Amendment Notice 3

Licensee	Northern Star Resources Ltd
ACN	092 832 892
Licence Number	L7969/2004/3
File Number:	DER2013/0000991
Premises	Paulsens Gold Project Mining Leases M08/99 and M08/196 Nanutarra-Munjina Road PARABURDOO WA 6754
Date of amendment	21 April 2017

This notice of amendment implements changes to the tailings storage facility (TSF) groundwater monitoring requirements specified under condition 5(b) of Licence L7969/2004/3 and removes condition 18 which required the development and implementation of a Groundwater Management Plan.

ATTACHMENT 5: LOCATIONS OF TAILINGS GROUNDWATER MONITORING POINTS PB45 AND PB70 (PRODUCTION BORES)

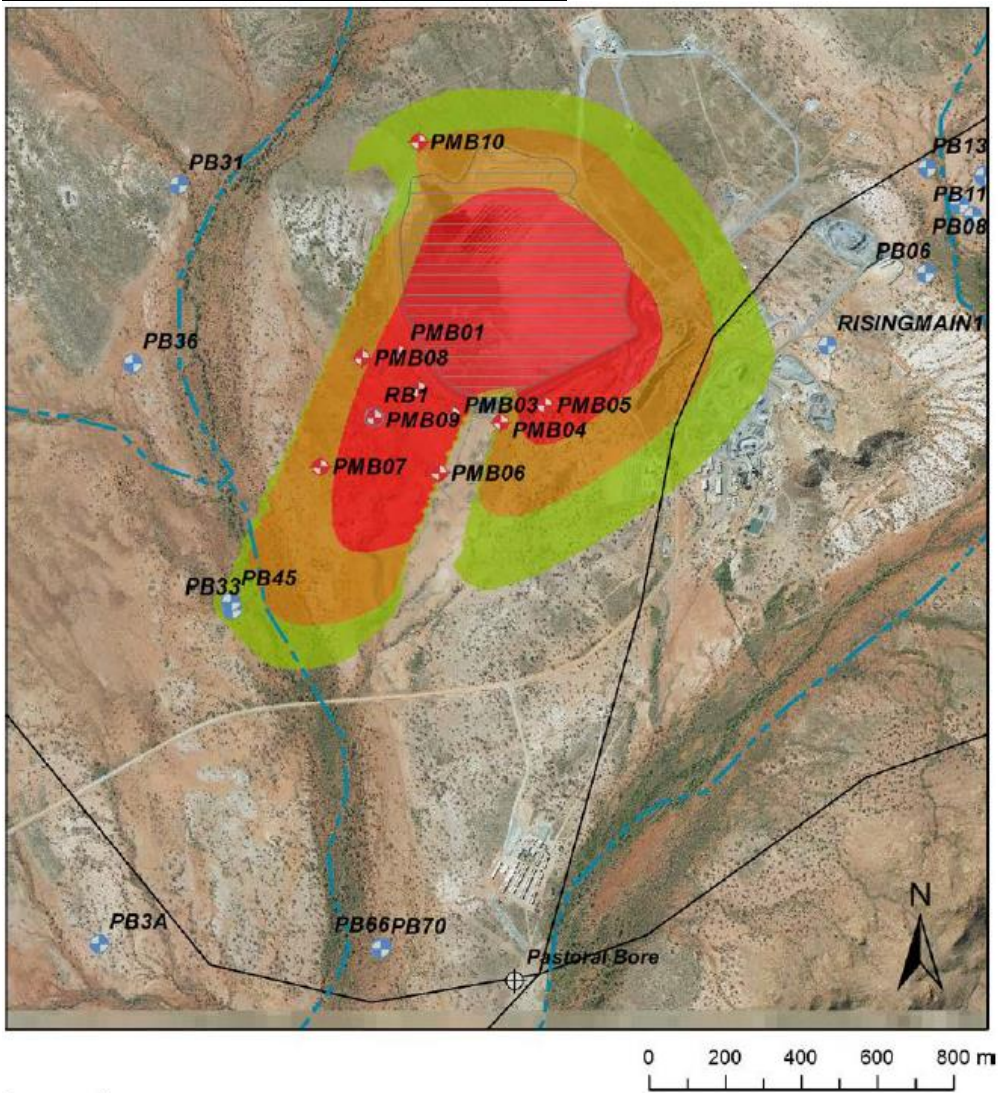
Figures depicting the location of production bores PB45 and PB70 has been included in the Licence as Attachment 5 to Licence L7969/2004/3.

- The licence is amended by the inclusion of the following figures as Attachment 5 and Attachment 6 to Licence L7969/2004/3:
